Subject: MHI's Response to US-APWR DCD RAI No. 297-2287 Revision 2

MHI's Response to US-APWR DCD RAI No. 297-2287 Revision 2

**US-APWR Design Certification
Mitsubishi Heavy Industries
Docket No. 52-021**

RAI NO.: NO. 297-2287 REVISION 2
SRP SECTION: 15 – INTRODUCTION – TRANSIENT AND ACCIDENT ANALYSES
APPLICATION SECTION: 15.0.0
DATE OF RAI ISSUE: 5/04/2009

**Figure 15.0.0-3.15 Reactor Power versus Time with and without LOOP
Steam System Piping Failure
- Case C: Limiting case for spectrum of breaks at 100% power**

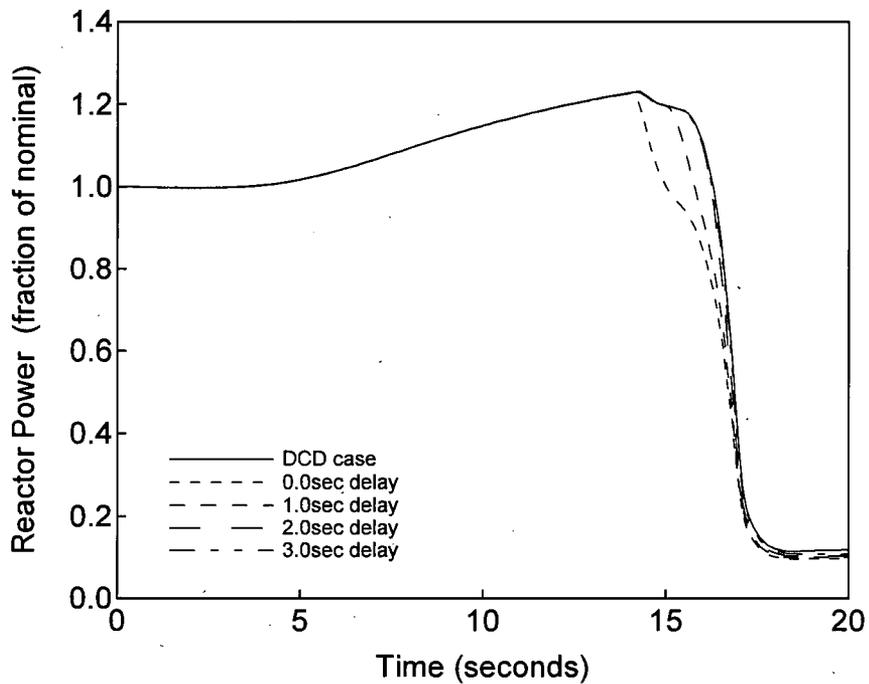
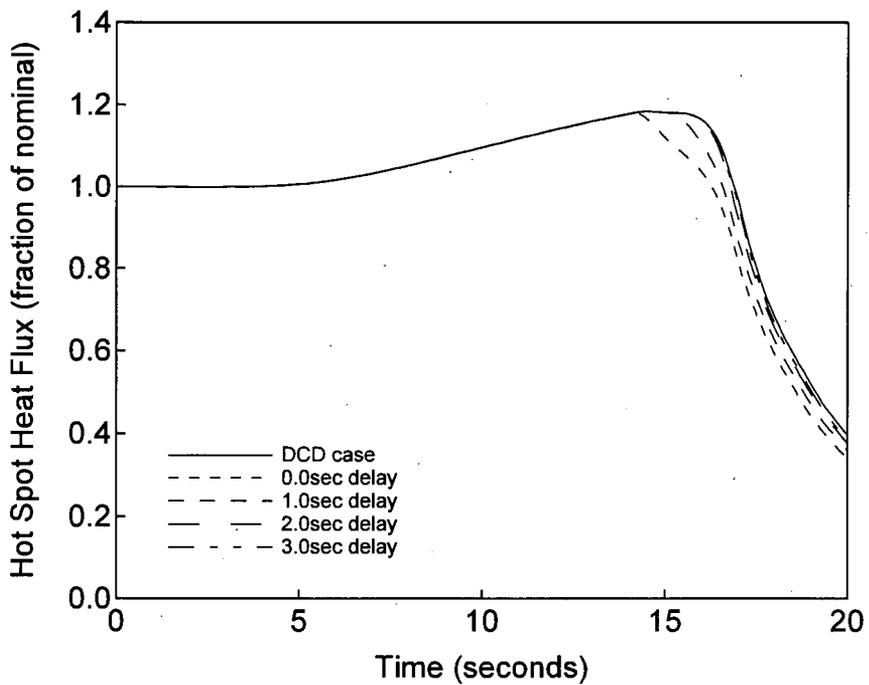
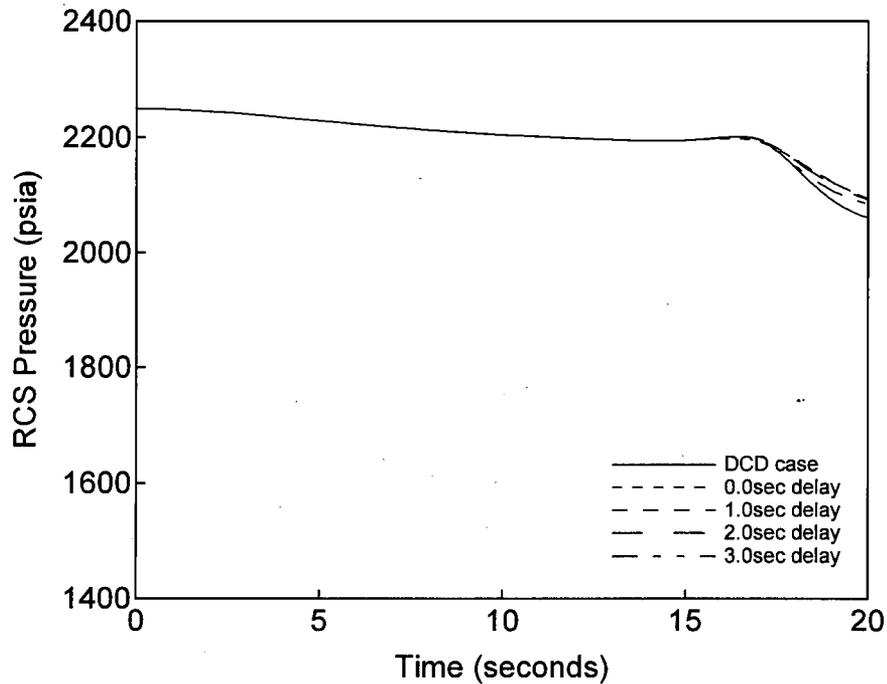
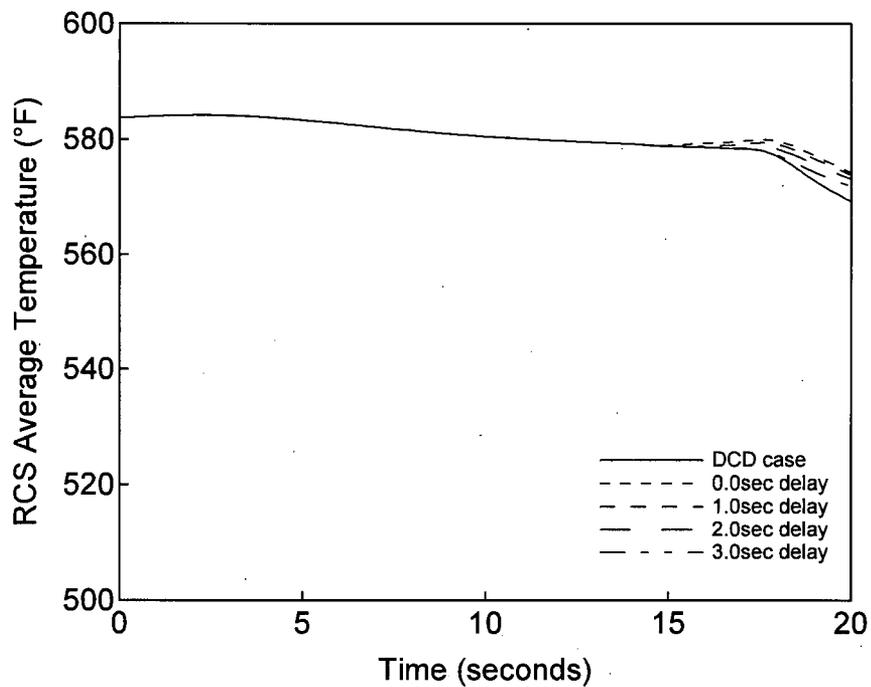
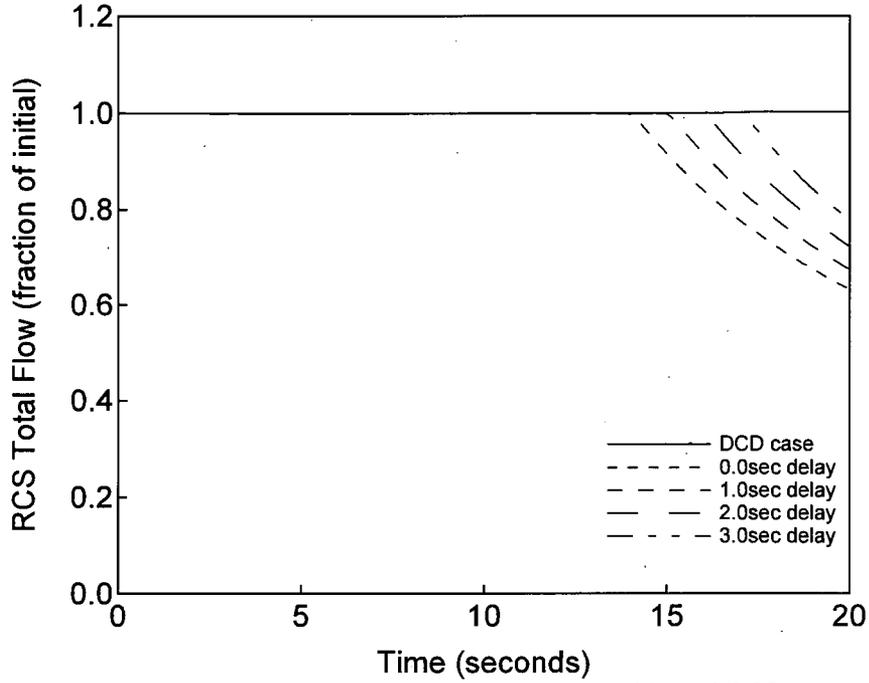
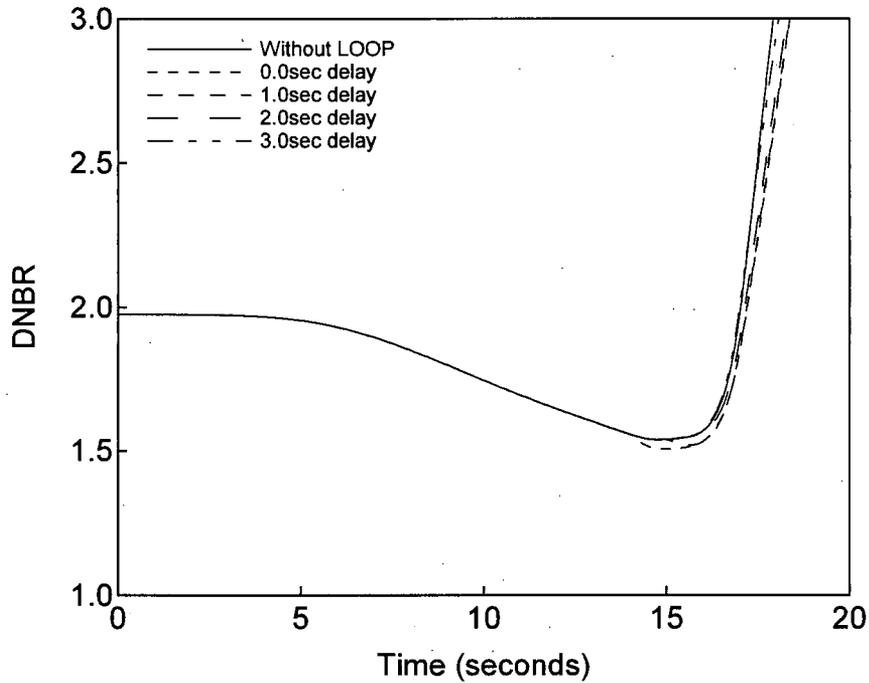
In DCD Section 15.0.0.7, the applicant presents arguments concerning the timing of a LOOP with respect to the timing of reactor trip and RCP coast down. By assuming a time delay in the onset of a LOOP, the onset of DNBR is decoupled from the availability of offsite power because the rods are inserted to the dashpot by the time the LOOP is initiated; therefore, the RCPs continue to run until the rods have been inserted in the core. This argument repeats itself throughout many Chapter 15 scenarios, allowing for the neglect of any LOOP consequences. Please provide more substantial arguments in defense of this assumed time delay, supported by sensitivity calculations that directly address this issue. (see also Question 15.1.2-1).

The results of the DNBR sensitivity analysis of these four events validate the assumption described in DCD Subsection 15.0.0.7 (and reiterated in event-specific subsections) that, with a 3 second delay between the turbine-generator trip and LOOP, the minimum DNBR is the same for the case with and without LOOP. The results of this sensitivity also show that there is some available margin in the delay time assumed since the minimum DNBR is the same for the case with LOOP assuming a 2 second delay and without LOOP. In addition, while the minimum DNBR for the 1 second delay cases were slightly worse than the cases without LOOP, the DNBR remained above the safety analysis analytical limit. Since the four events selected for this sensitivity analysis were representative DNBR events in Chapter 15, the remaining DNBR analysis in Chapter 15 would also be adequate even assuming a 1 second delay (excluding those events that already violated the DNBR limit, such as the RCP rotor seizure). Although the results showed that the two 0 second delay RWP cases result in a minimum DNBR below the acceptance limit, the US-APWR DCD contains COL Item 8.2(11) which requires that the COL applicant perform a grid stability analysis to confirm that the LOOP occurs at 3 seconds or greater. This is also described in the response to Question 15.0.0-4 of this RAI.
